Introduction

Thank you for your interest in the Xilinx XCF08P, XCF16P, & XCF32P PROM products. Although Xilinx has made every effort to ensure the highest possible quality, these devices are subject to the limitations described in this Errata notification.

This erratum applies only to the XCF08P, XCF16P, & XCF32P PROMs. This erratum does not apply to any other Xilinx PROMs.

Figure 1: Left, TSOP-48 (VO48) Package; right, FBGA-48 (FS48) Package
Legend: a = alphanumeric characters; ddd = 3-character numeric date code.

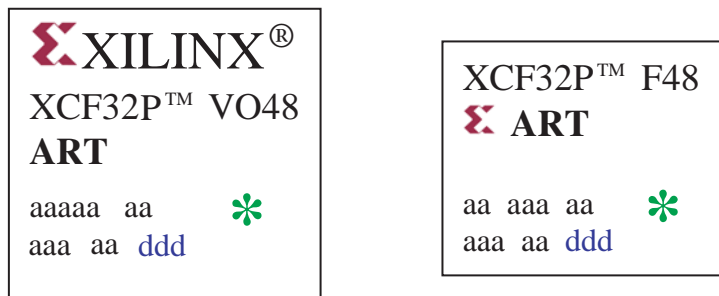
The affected devices have date codes 522 and older (i.e., work week 22 in the year 2005, or older).

1. Ensure that VCCint ramps up to 1.6V faster than 1ms for the affected devices listed above
2. Xilinx implemented a test program to ensure the devices meet the Power on Reset Activation specification. Order parts that have been screened. Screened parts will have an asterisk mark (“*”) on the top side (see Figure 1, above). For ordering instructions, please contact your Xilinx Sales Representative.

Figure 2: Requirements for VCC_{INT}

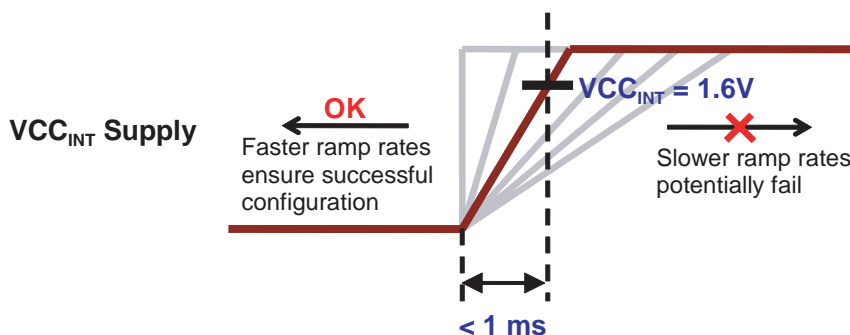
Some of the devices listed above may fail in some applications during “Power on Reset Activation.” Devices that have a VCCint ramp during “Power on Reset Activation” that is slower than 1ms may see failures.

XCF08P, XCF16P, and XCF32P devices that have a VCCint ramp during “Power on Reset Activation” that take longer than 1ms to reach 1.6V may potentially see failures. The following diagram describes the region of operation for parts that are affected by the errata.
